Access Compliance Report Public Rights-of-Way (Curb Ramps)

Main Street: SECOND_ST	Cross Street: MAIN_ST	Location: N
-------------------------------	------------------------------	--------------------

ADA ID: RPRK211026170427	Ramp Type: Type 4 - Parallel	Initial Pass/Fail: Fail	Overall Compliance: No	Severity Score: 16
---------------------------------	-------------------------------------	--------------------------------	-------------------------------	---------------------------

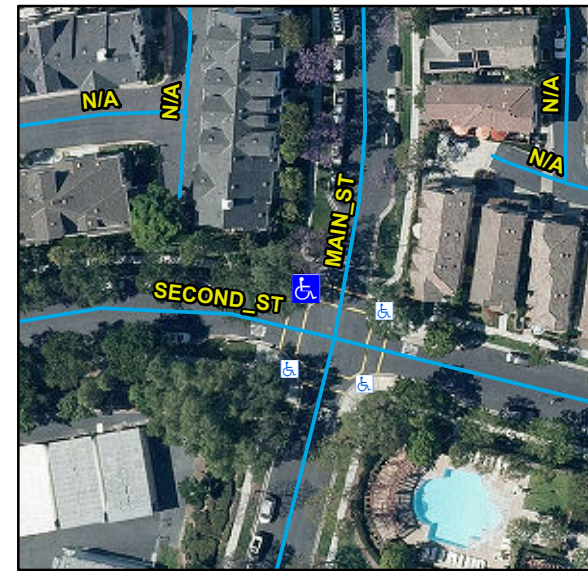
Compliance	Description	Data	Compliance	Description	Data
N/A	Ramp Length LT (in)	100	N/A	Ramp Length RT (in)	105
Yes	Ramp Width LT (in)	90	Yes	Ramp Width RT (in)	90
Yes	Ramp Run Slope LT (%)	1.6	No	Ramp Run Slope RT (%)	9.6
No	Ramp Cross Slope LT (%)	2.3	Yes	Ramp Cross Slope RT (%)	1.2
N/A	Landing Present	N/A	N/A	DWS Provided	N/A
N/A	Landing Length (in)	N/A	N/A	DWS Contrast	N/A
N/A	Landing Width (in)	N/A	N/A	DWS Length (in)	N/A
N/A	Landing Run Slope (%)	N/A	N/A	DWS Full Width	N/A
N/A	Landing Cross Slope (%)	N/A		DWS Offset Type	N/A
N/A	Landing Movement Obstructed?	N/A	N/A	DWS Offset Left (in)	N/A
	Landing Movement Type	N/A	N/A	DWS Offset Right (in)	N/A
N/A	Landing Shared	N/A			
N/A	Clear Space	Yes			
N/A	Clear Space To Crosswalk (in)	N/A			
N/A	Marked Crosswalk 1	No	N/A	Marked Crosswalk 2	No
	Crossing 1 Direction	SW		Crossing 2 Direction	SE
	Marked Crosswalk 1 Width (in)	N/A		Marked Crosswalk 2 Width (in)	N/A

Remove & Replace Curb Ramp With Two New Directional Ramps or Equivalent.

R204.3, R304.5.3, R304.3.2, STD 1115
